LAKE PONTCHARTRAIN, L.A.
AND VICINITY
**LAKE PONTCHARTRAIN
HIGH LEVEL PLAN**

**DESIGN MEMORANDUM NO. 20
GENERAL DESIGN**

**ORLEANS PARISH
JEFFERSON PARISH
17th. St. Outfall Canal
(Metairie Relief)**

CELMV-ED-PG (CELMN-ED-SP/15 May 90) (1105-2-10c) 3d End
Mr. Eckenrod/ts/5925
SUBJECT: Lake Pontchartrain, Louisiana and Vicinity, High Level Plan, Design
Memorandum No. 20 - General Design, 17th Street Outfall Canal

ENCL. 29

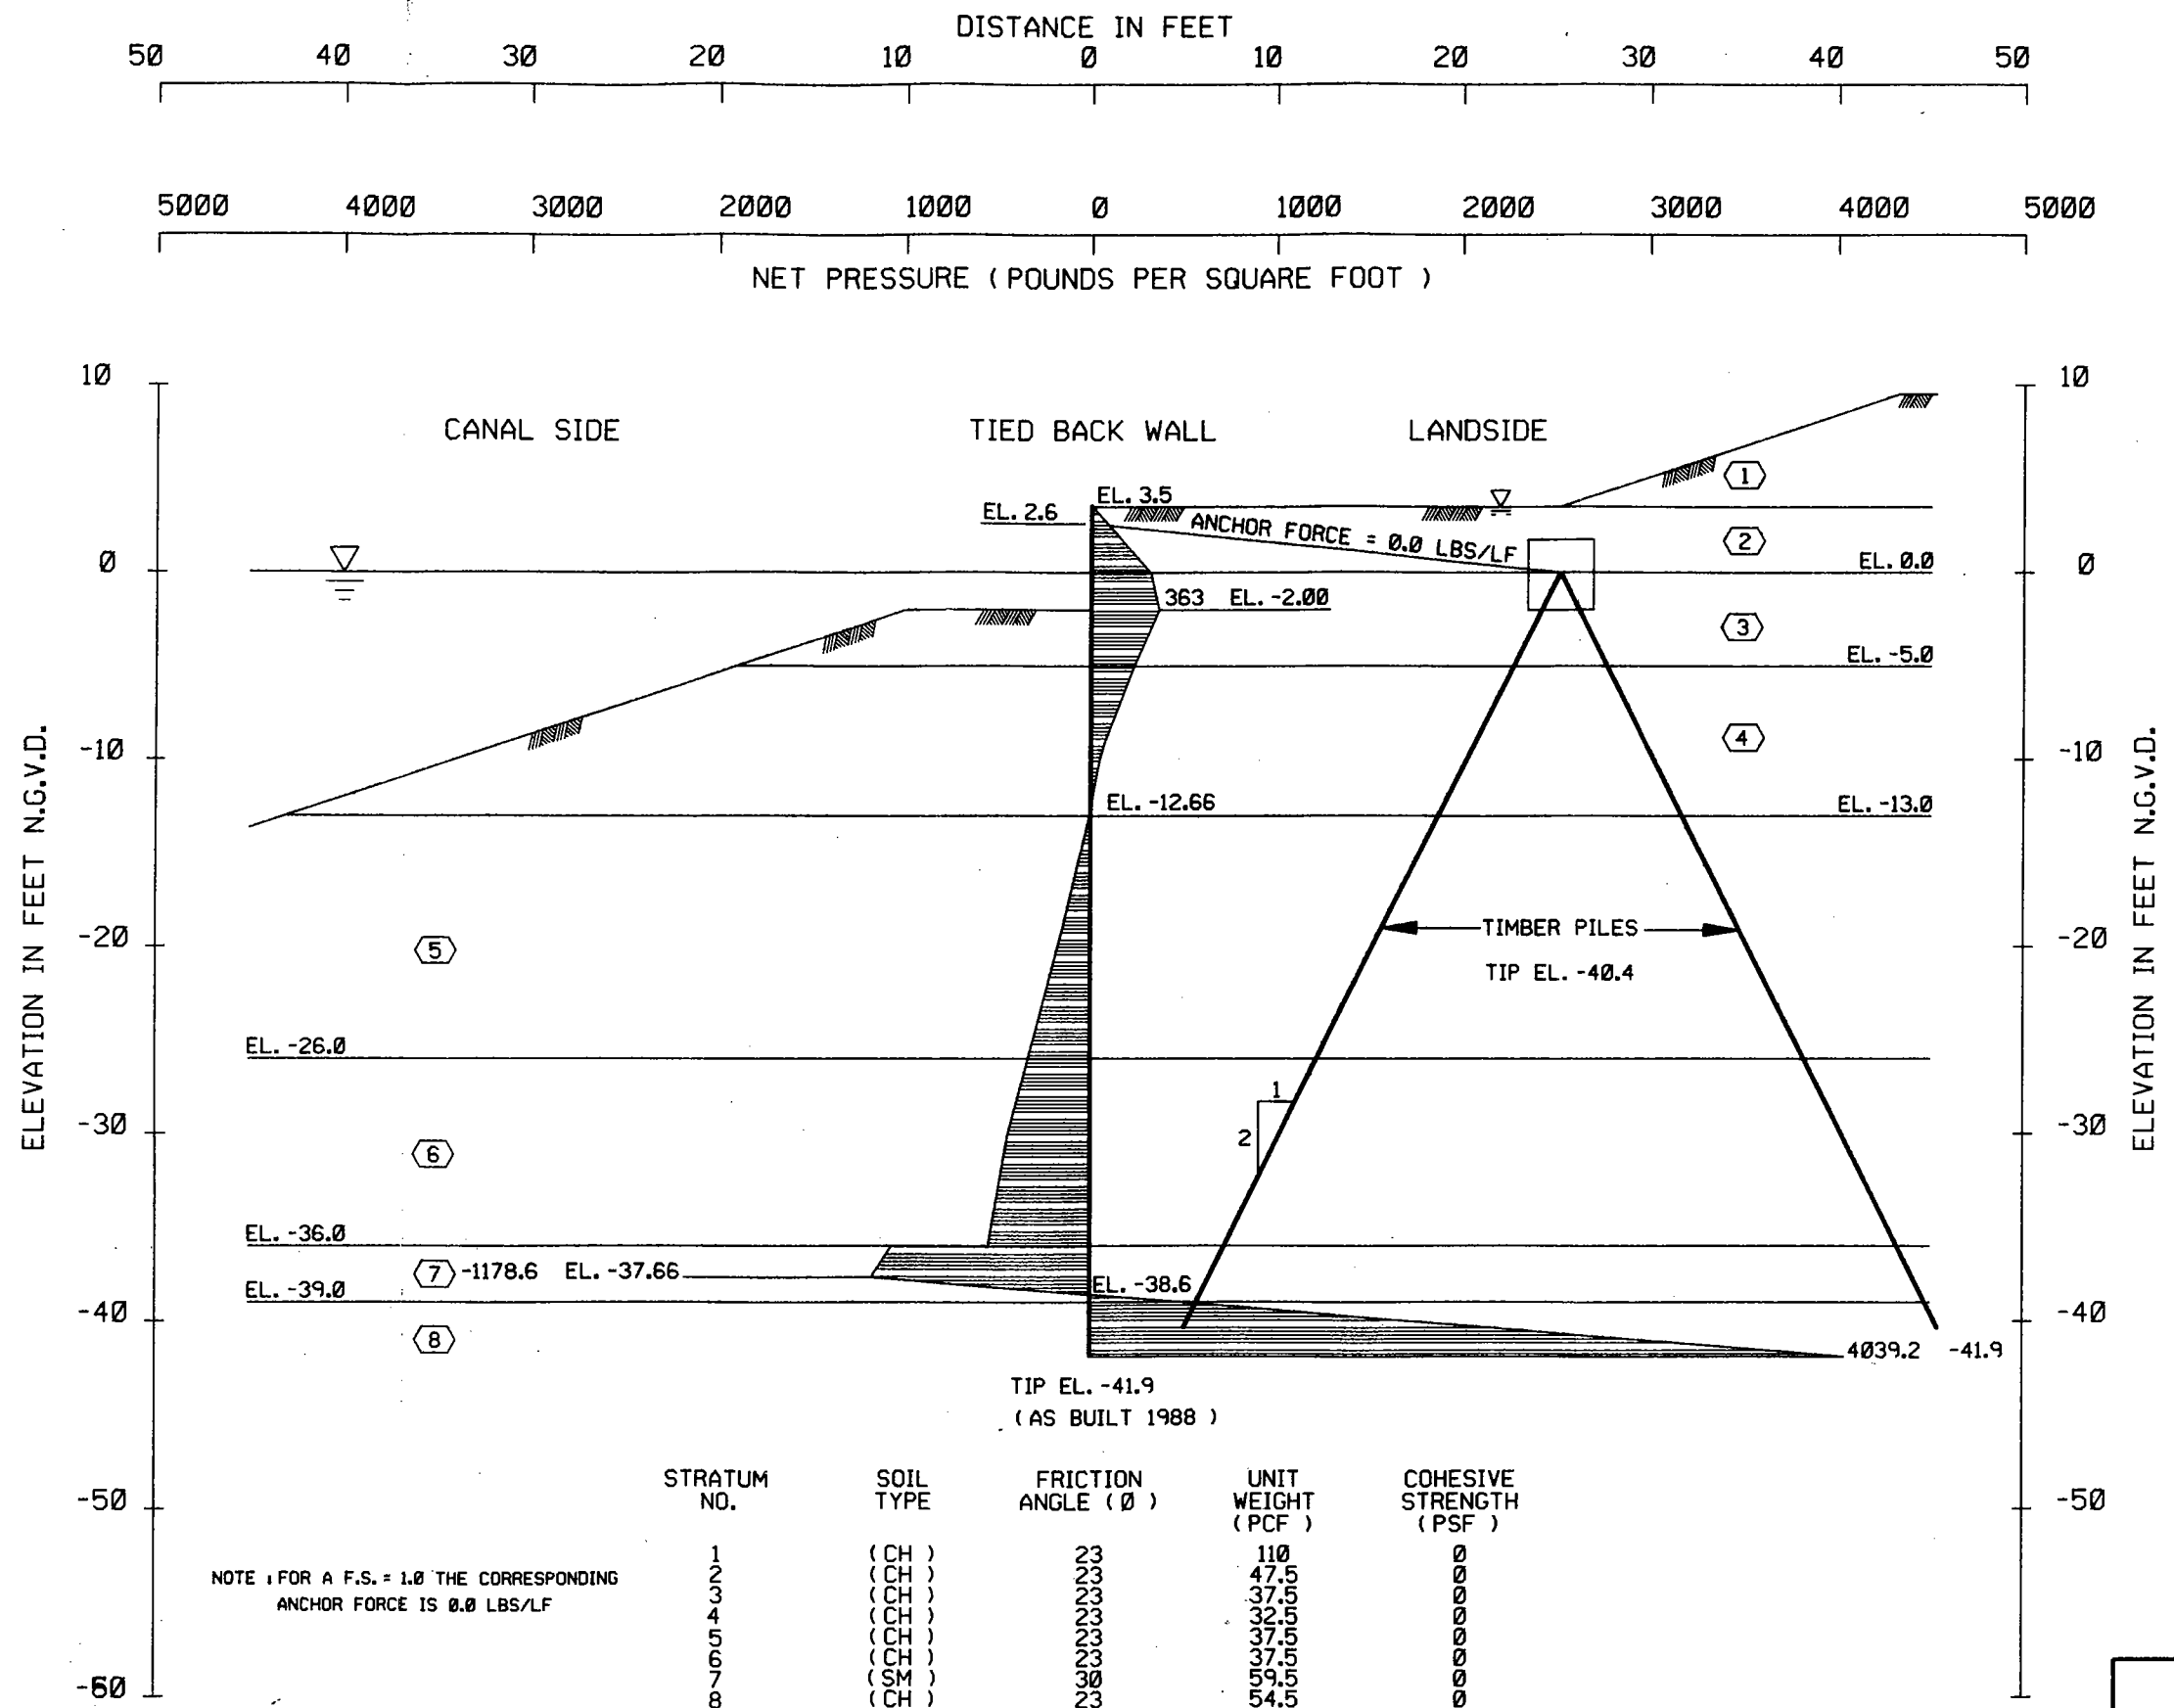
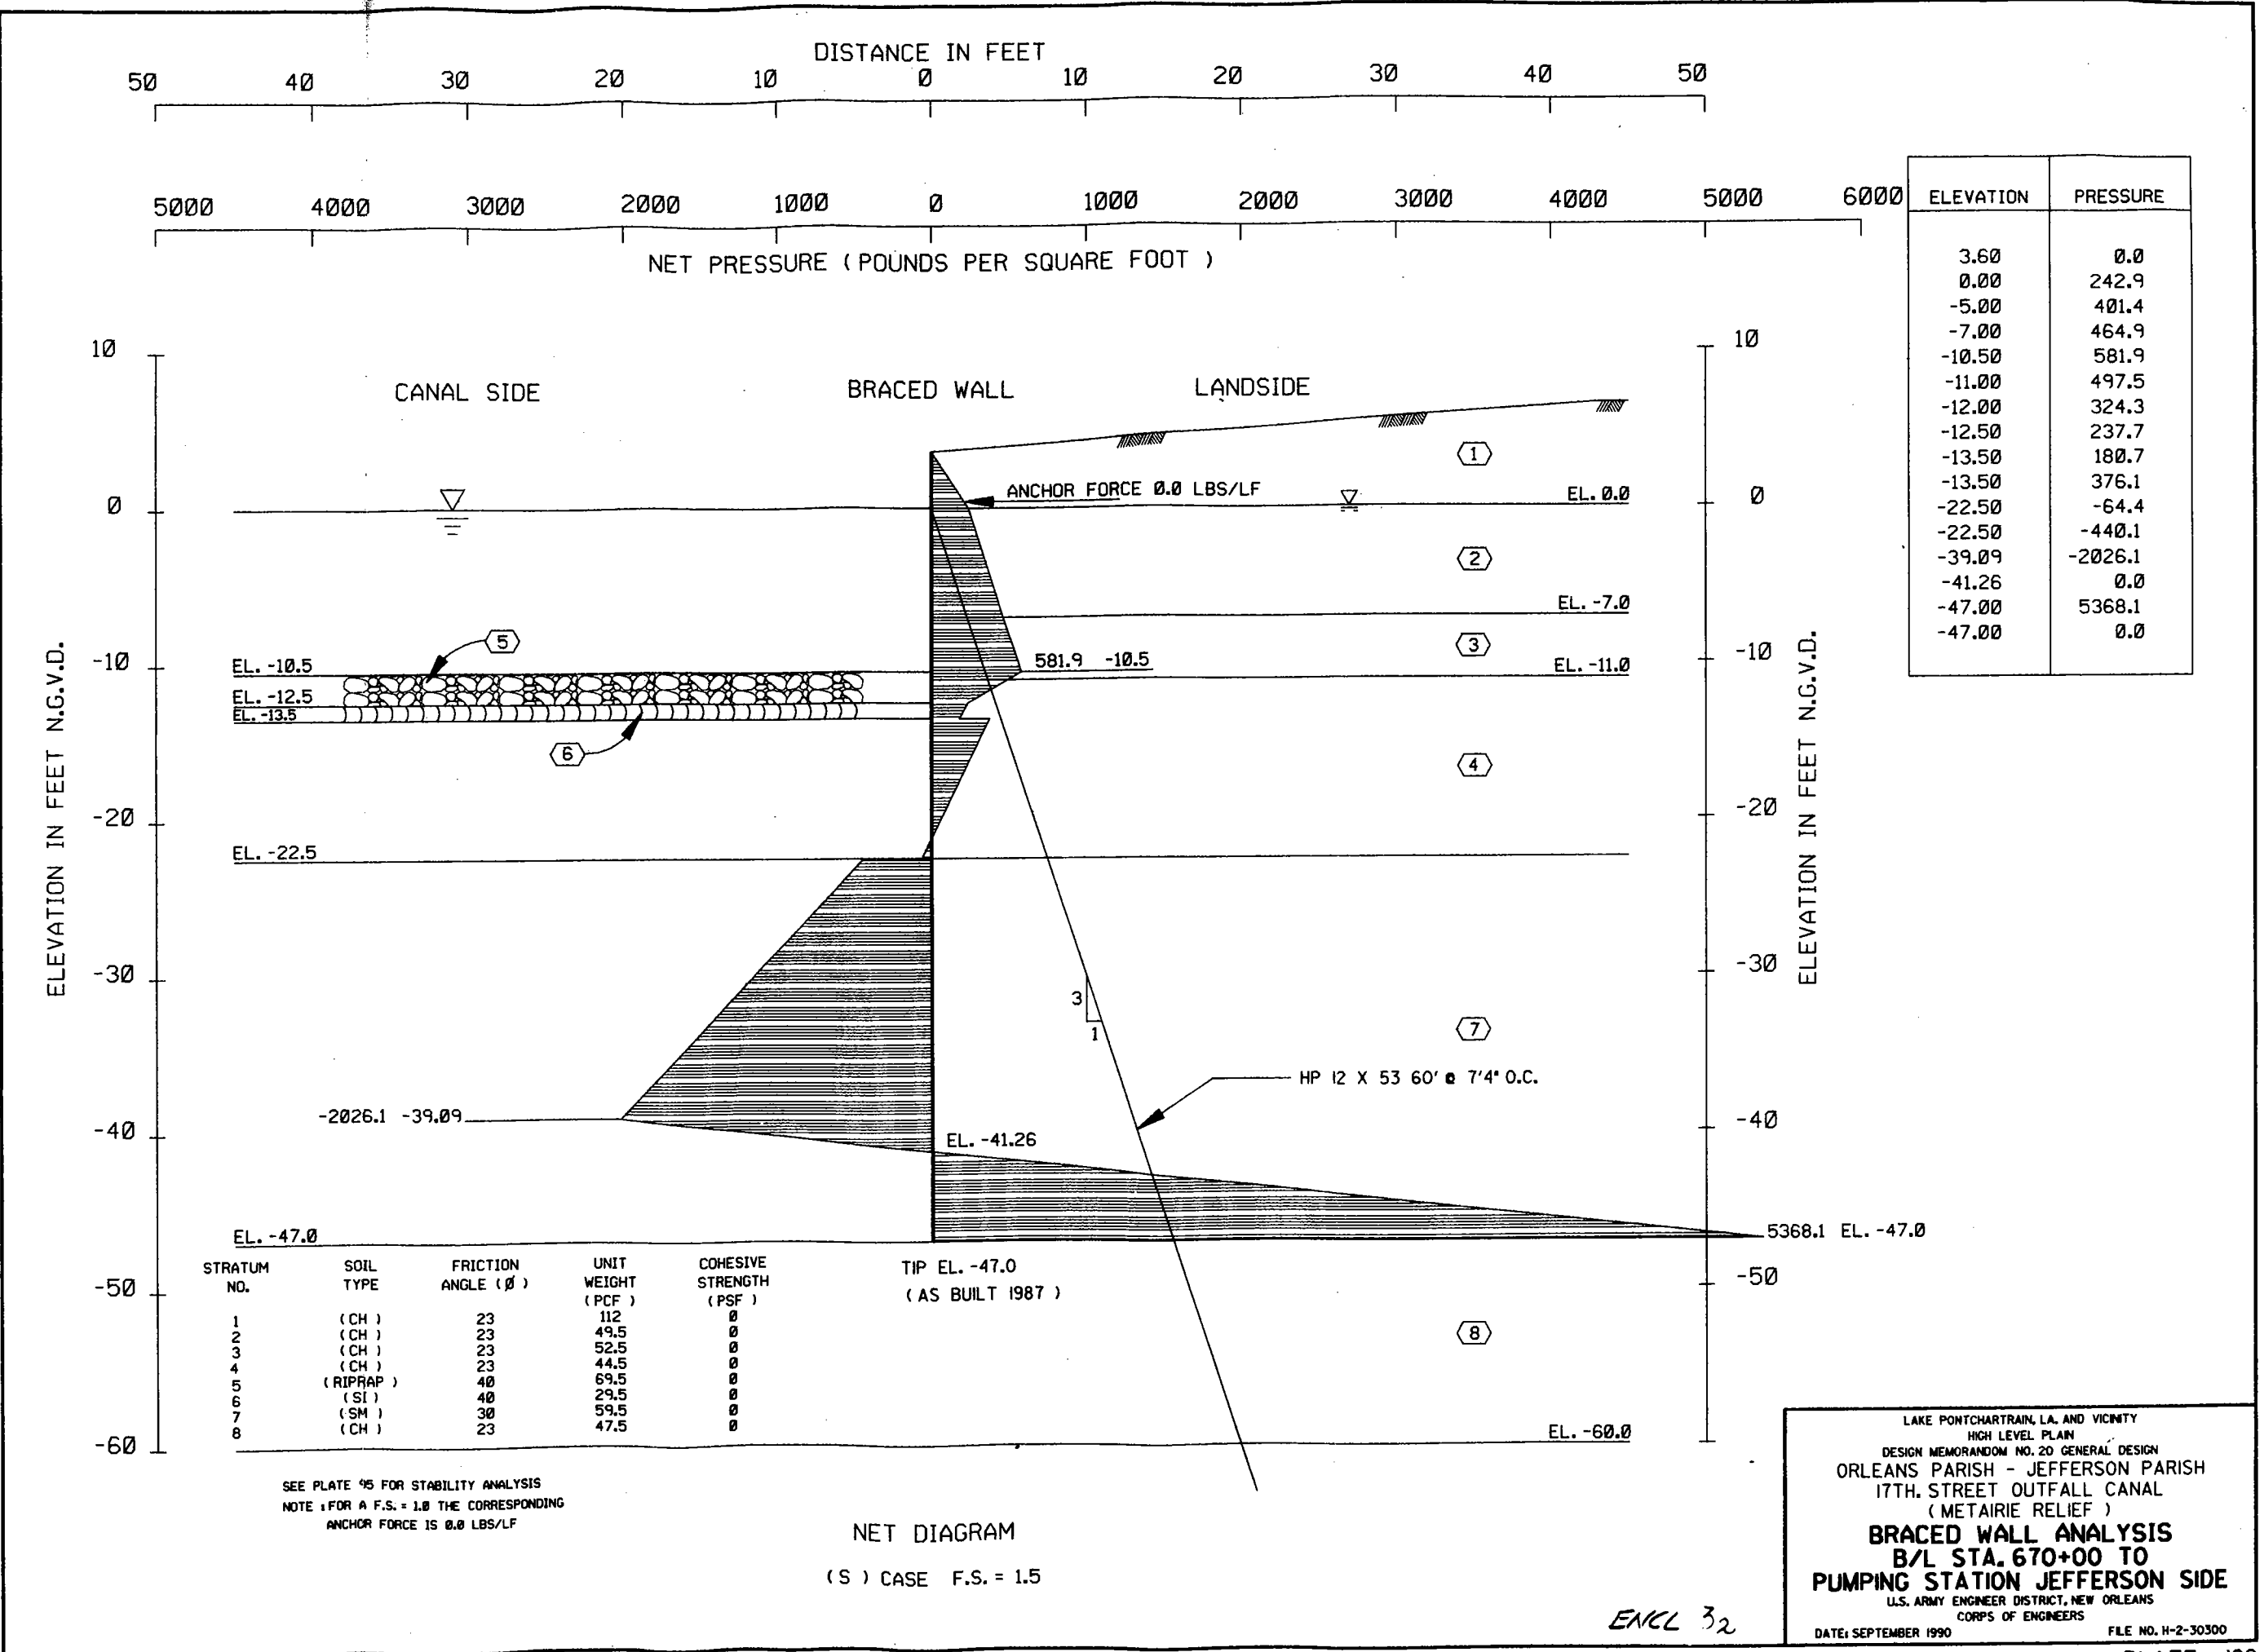
d. Para 29c. Also refer to the tied back and braced wall analyses on Plates 121-124. These analyses are based on the "Q" case soil strengths, a canal level at el -5.0, and a factor of safety of 1.5. Since these sheet pile bulkheads permanently retain soil, they should also be analyzed using "S" soil strengths, a factor of safety of 1.5, and at the normal canal level of el 0.0.

m. Plates 121 through 124. The walls shown on these plates should be evaluated for the anchor forces and resulting stresses on the anchors and the sheet piling should be checked using the conditions shown except change the water level on the canal side to el 0.0 NGVD and use soil properties for the 'S' case and a F.S. = 1.5.

d. Comment d. Para. 29c. The analyses presented were for the Q-CASE soil strengths, a canal level at EL. -5.0 and a factor of safety of 1.5. For plates 121, 122, and 124 the actual design (completed before Dec 87) was controlled by the S-CASE, F.S. = 1.5, and canal level at EL -5.0. The design on plate 123 (completed after Dec 87) was based on the S-CASE F.S. = 1.2 with canal level at EL -5.0; S-CASE F.S. = 1.5 with canal level at EL 0.0; or the 3:1 penetration to head ratio. All the braced walls and tieback walls have been constructed. The tip penetrations shown on plates 122-124 are deeper than the minimum required tip penetration (Encl 3). Intermediate tip penetrations were used to reduce the anchor forces.

m. Comment m. Plates 121 through 124. Concur. Revised plates 121 through 124 are enclosed as Encl 3.
